# STRATHFIELD LOCAL PLANNING PANEL MEETING AGENDA

TO: Strathfield Local Planning Panel Meeting - 12 December 2024  
 REPORT: SLPP –Report No. 14  
 SUBJECT: **S8.2-DA2023.159 - 51 SOUTH STREET, STRATHFIELD**  
 DA NO. **S8.2-DA2023.159**

<b>Property:</b>	51 South Street STRATHFIELD DA 2023/159
<b>Proposal:</b>	Section 8.2 Application to review previous determination to refuse the development for the demolition of existing structures and construction of a two-storey dwelling with basement, front fence and pavilion at the rear (DA2023/159).
<b>Applicant:</b>	S Diab
<b>Owner:</b>	S Diab
<b>Date of lodgement:</b>	7 October 2024
<b>Notification period:</b>	11 October 2024 to 26 October 2024
<b>Submissions received:</b>	Nil
<b>Assessment officer:</b>	Bismark Opoku-Ware
<b>Estimated cost of works:</b>	\$2,773,931.00
<b>Zoning:</b>	R2-Low Density Residential - SLEP 2012
<b>Heritage:</b>	No
<b>Flood affected:</b>	<b>Yes – Flood affected</b>
<b>Is a Clause 4.6 Variation Proposed:</b>	No
<b>Local Planning Panel Criteria</b>	Internal Delegations
<b>RECOMMENDATION OF OFFICER:</b>	Approval subject to conditions

**Figure 2: 8.2 Review basement level.**

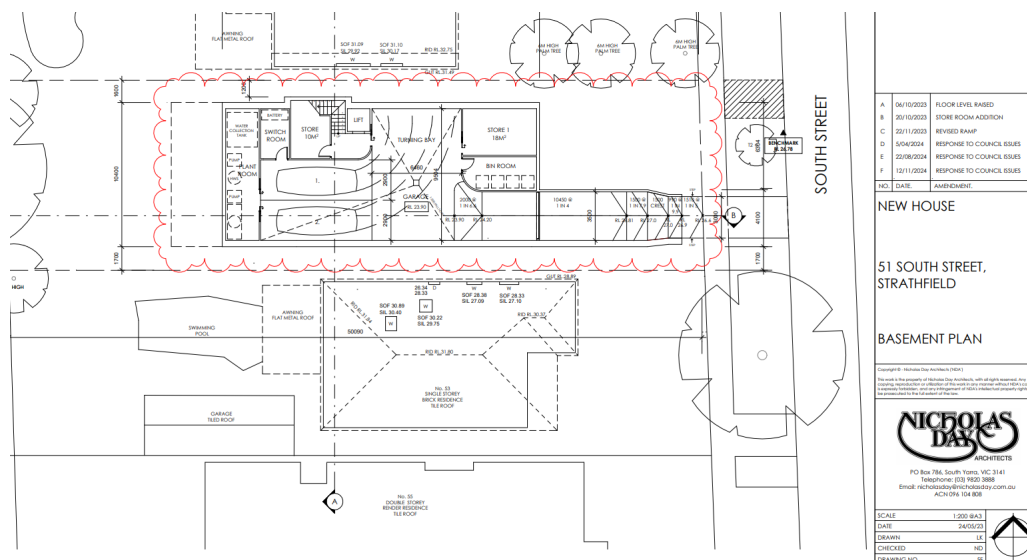
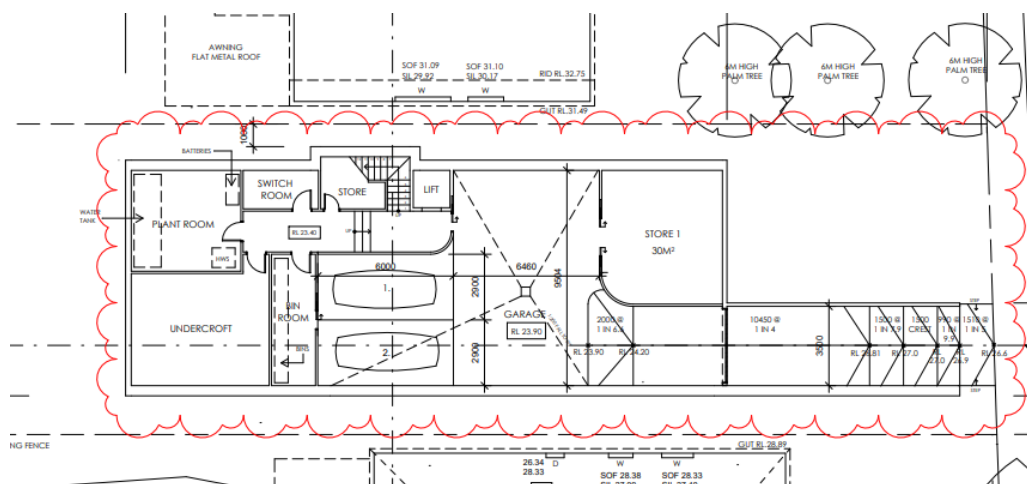
**Planner's comment:** The 8.2 application proposes changes to the basement level. The floor area is reduced by approximately 10sqm, deleting the undercroft and introducing minor internal reconfiguration. Notably, the 8.2 Review basement has no areas included in the gross floor area. The proposed basement is maintained within the ground floor building footprint and maintains a maximum vertical projection of 988mm from existing ground level to the floor above at the front section of the dwelling house.

Figure 4: 8.2 Review ground floor plan.

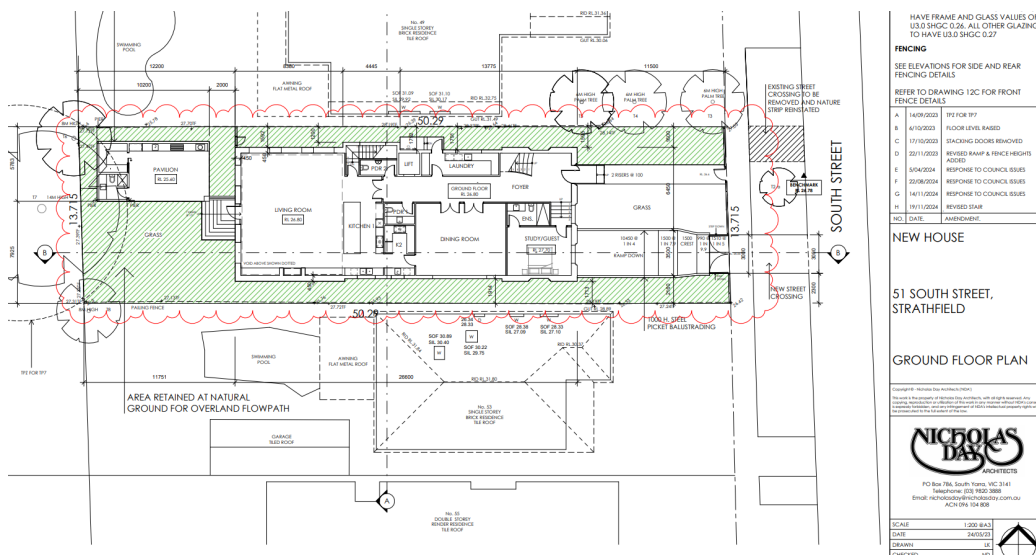
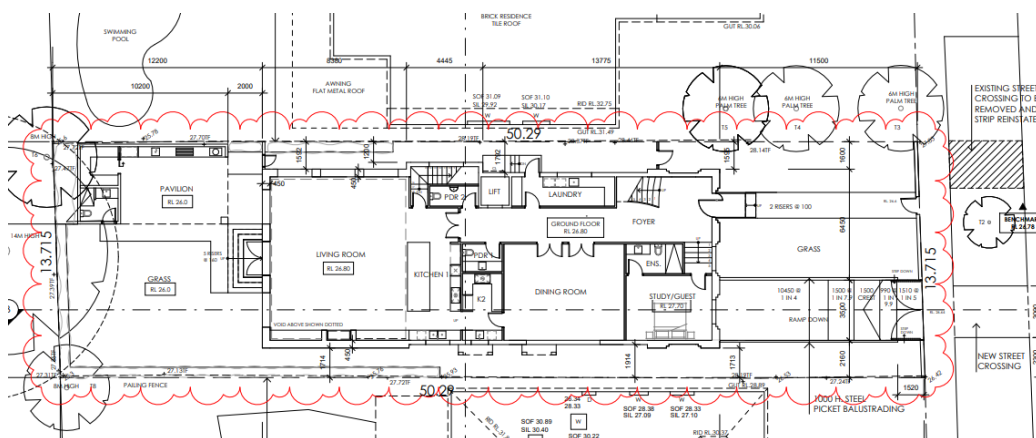
**Planner's comment:** The ground floor level drawing for the 8.2 Review proposes no changes in terms of internal room layout. However, it is noted that increased setbacks are proposed for the detached pavilion. The 8.2 Review maintains the minimum southern side setback of 1.713m and 1.2m northern side setback for the dwelling house. However, 1.2m side and rear setbacks are introduced for the pavilion. The amended external works remove the paved pathway leading to the pavilion and modify the rear stairs into the dwelling house. Furthermore, the 8.2 Review proposes a 3m driveway width at the lot boundary which complies with the provisions of the SCDP 2005. Notably, a 3.5m driveway was proposed in the refused development application which formed a reason for refusal.

**Figure 6: 8.2 Review first floor level plan.**

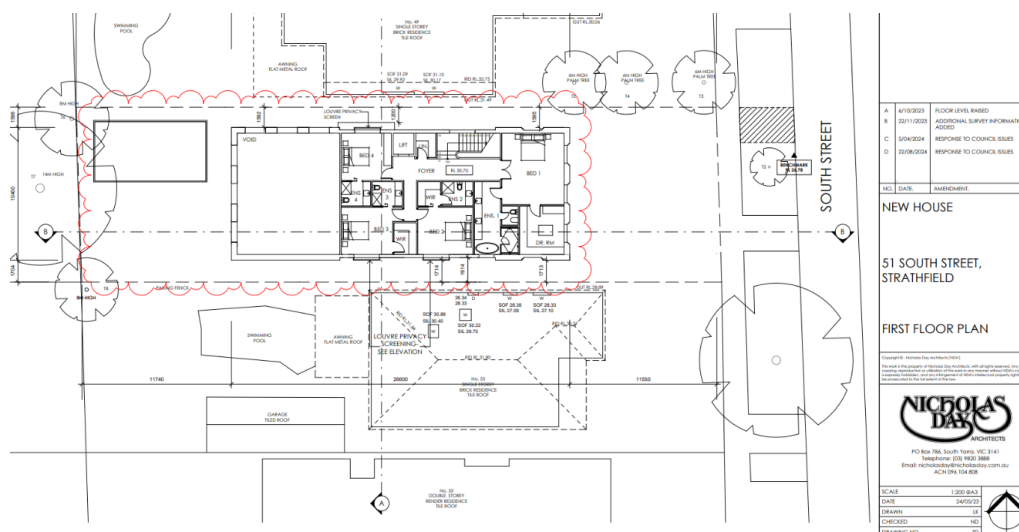
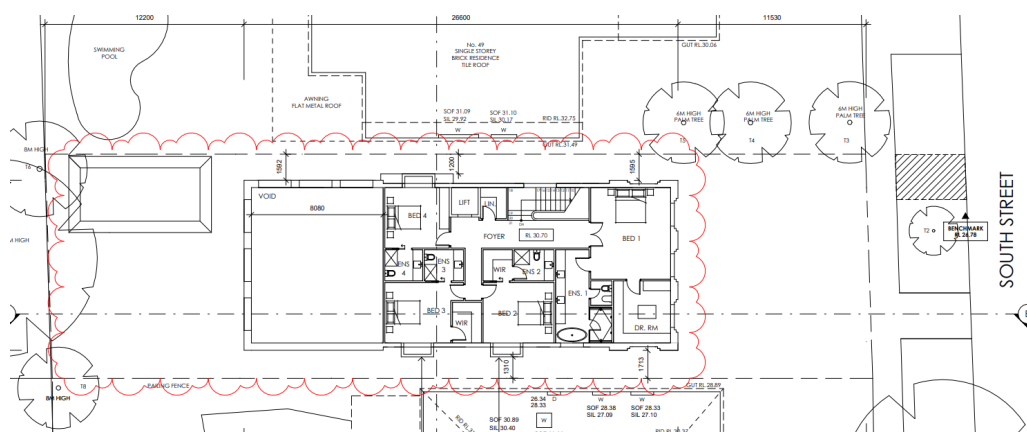
**Planner's comment:** The 8.2 Review first floor plan shows that the minimum southern first floor setback has been increased to 1.7m from 1.3m in the refused development application. The new setbacks comply with the minimum combined setback (20% of site width) control of 2.743m under the SDCP 2005. Accordingly, a combined side setback of 2.9m is proposed which complies with the SDCP 2005. The simplified flat roof form proposed in the 8.2 Review and new setbacks improve amenity for neighbouring dwellings. No internal room layout changes are made.

**Figure 8: 8.2 Review roof plan**

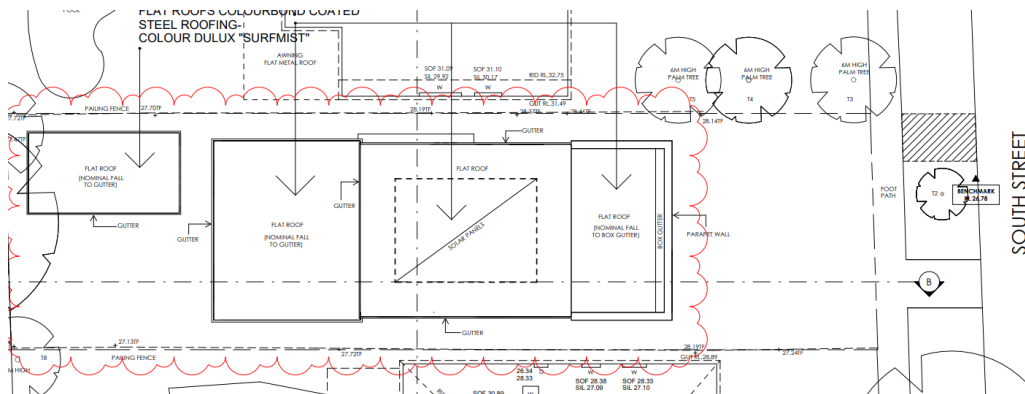
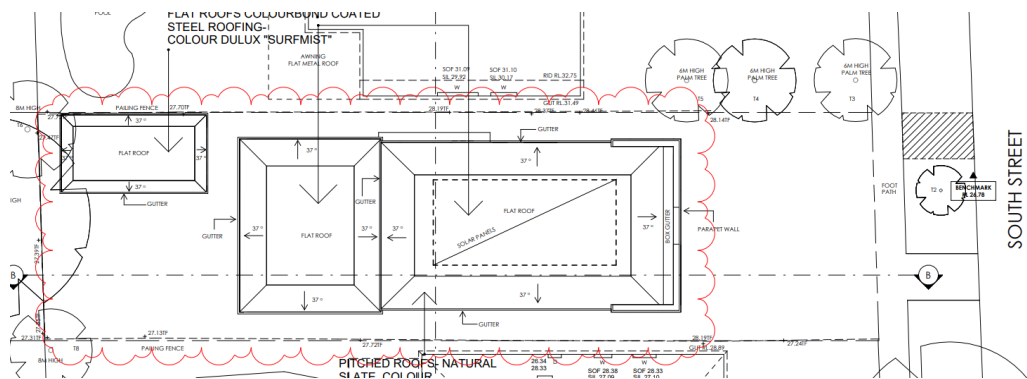
**Planner's comment:** The 8.2 Review roof plan shows that a simplified flat roof form is proposed for the dwelling house and the detached pavilion. Also, 1.2m side and rear setbacks are provided for the pavilion. The new setbacks afford adjoining developments to the north and west visual relief and improved amenity for adjoining developments.

**Figure 10:** 8.2 Review east (front) elevation plan.

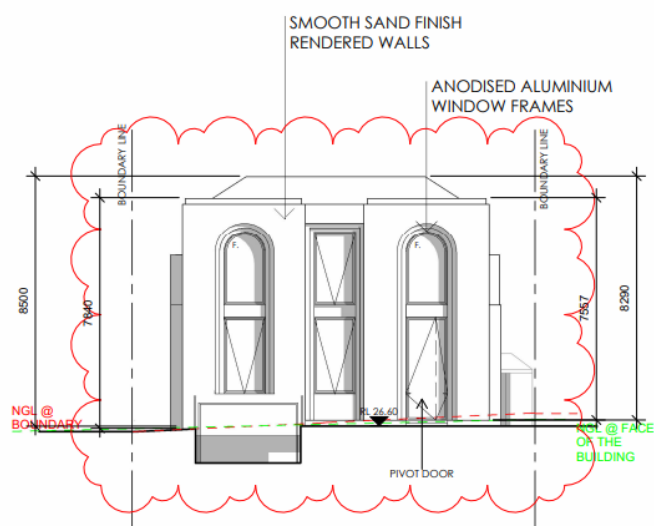
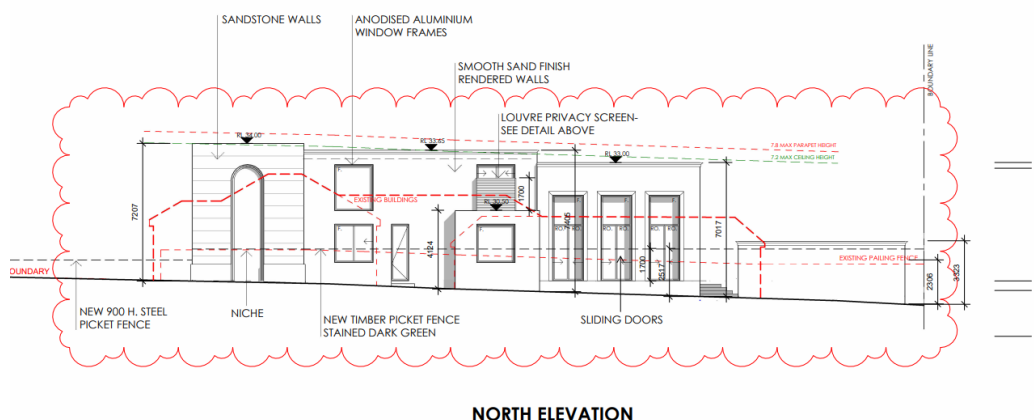
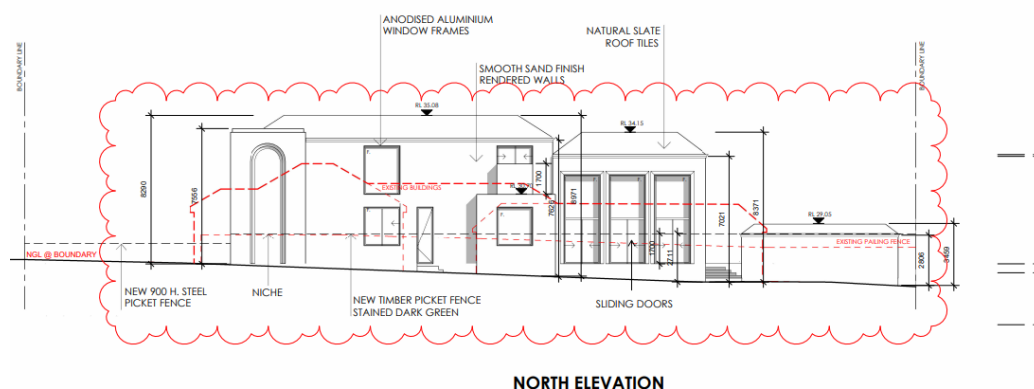
**Planner's comment:** The Section 8.2 east (front) elevation shows a simplified flat roof form which minimises the visual bulk of the building. Furthermore, the drawing shows a reduced front top of parapet height of 7.2m from the refused 7.55m.

**Figure 12:** 8.2 Review north elevation plan.

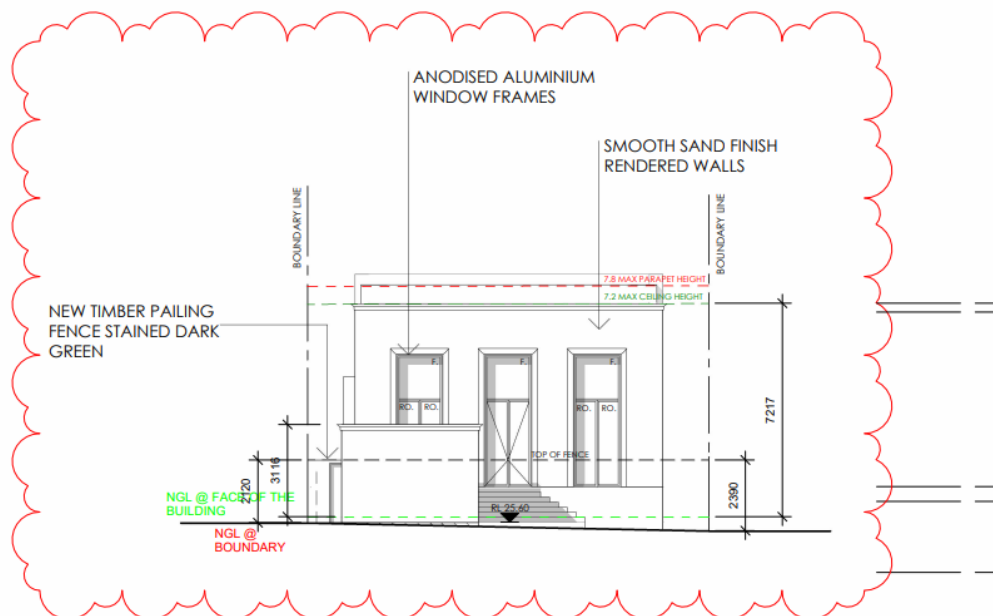
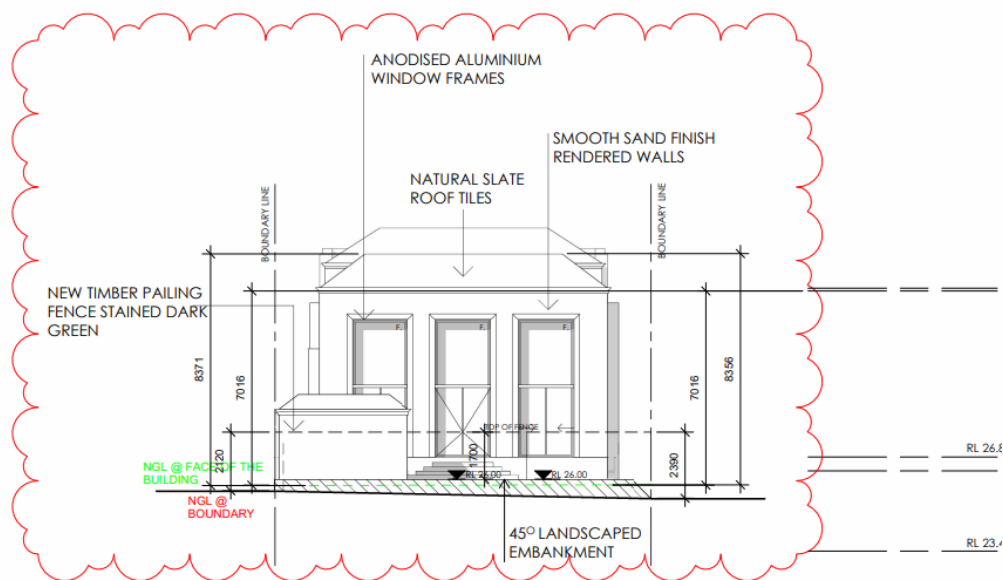
**Planner's comment:** The 8.2 Review north elevation plan shows a simplified flat roof form. Furthermore, the drawing shows a reduced roof pitch height from the refused height of 8.97m to 7.4m. The reduced building height and simplified roof form in combination with the northern side setback for the pavilion minimises visual bulk on the northern adjoining development. The plan include louvred privacy screens attached to the window of Bedroom 4 to protect privacy.

**Figure 16:** 8.2 Review south elevation plan.

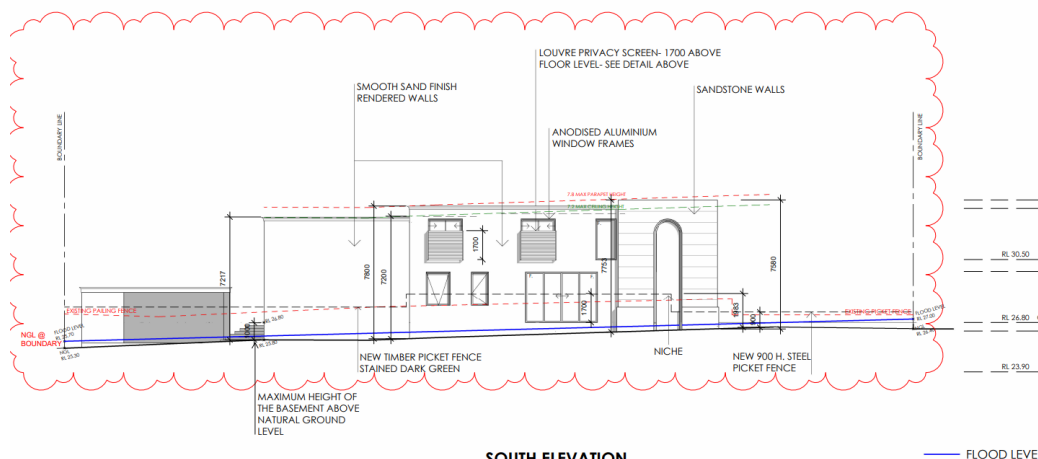
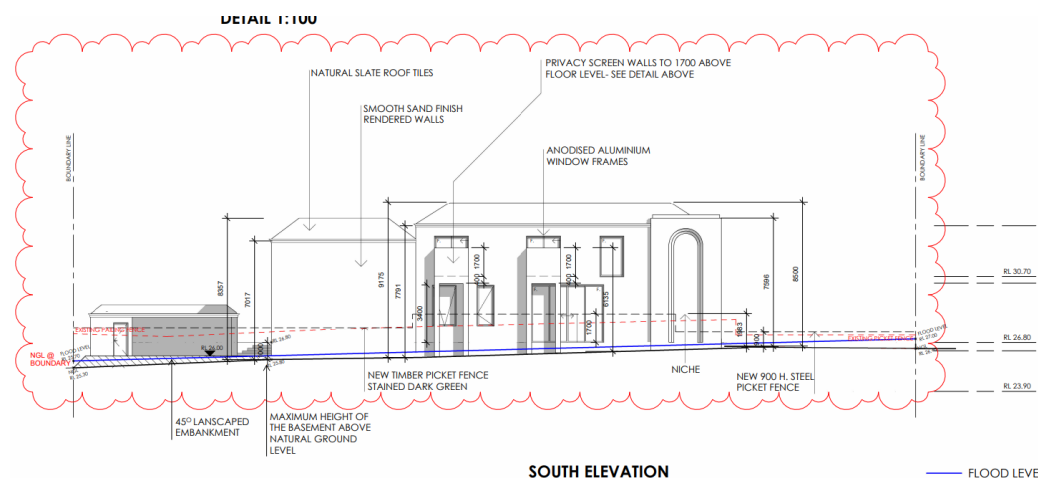
**Planner's comment:** The Section 8.2 south elevation shows a simplified flat roof form and deleted privacy walls. The drawing shows a reduced roof pitch height from the refused 9.17m to 7.8m. The reduced building height and simplified roof form in combination with the deleted privacy walls results in increased southern side setbacks, minimise visual bulk and overshadowing impacts on the southern adjoining development. The provision of louvered privacy screens for Bedroom 2 and 3 windows also ameliorates overlooking impacts on the adjoining property. The Section 8.2 south elevation plan further shows that the fill proposed in the rear yard has been deleted. This appropriately minimises earthworks on the site, reduces

risk associated diversion of the overland flow path and facilitates an appropriate stormwater drainage arrangement for the site.

**Figure 18:** 8.2 Review front fence.

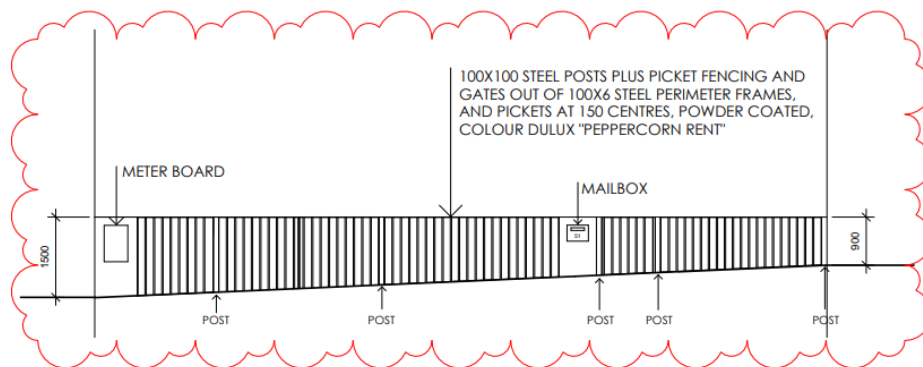
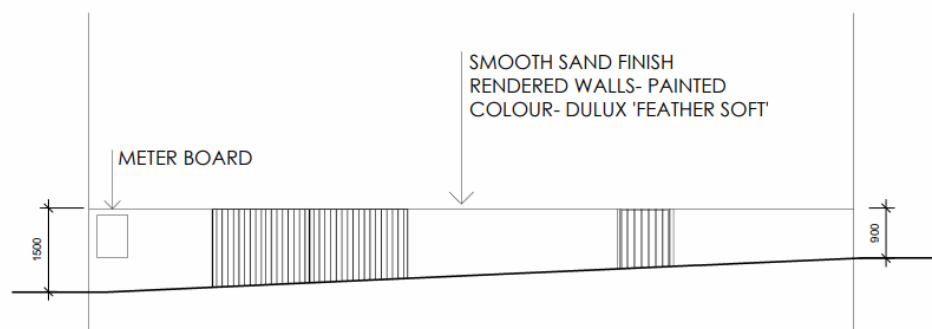
**Planner's comment:** The front fencing proposed in the Section 8.2 application has been amended to provide an open style fencing for visual permeability to enable casual surveillance with exceptions to sections where a letterbox and meter board is incorporated and gate. The achieves a maximum height of 1.5m and has been amended. The new front fence is considered acceptable.
